Planning application No 2017/4422	Date: 08/11/17	Revision :	
Proposal:	New side dormer and refurbishment or dormer	f existing front and rear	
Location: Applicant:	Flat B, 160 Camden Road, London, NW Mr Simon Burbidge	at B, 160 Camden Road, London, NW1 9HJ Simon Burbidge

This Design and Access statement (DAS) has been developed to address comments raised by Mark McCarthy from the Rochester Conservation area.

Photo No3 - View taken at street / pavement level of property No188

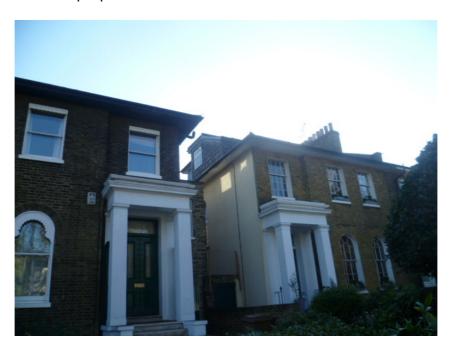
The buildings in the street are detached residential. The adjoining buildings are of the same design, storey, and height with pitched slate roofs. The plan forms of the buildings in the area and the detailing of the buildings varies to a great extent. There are also a number of properties (188, 186, and 164) with side dormers larger than what we propose.
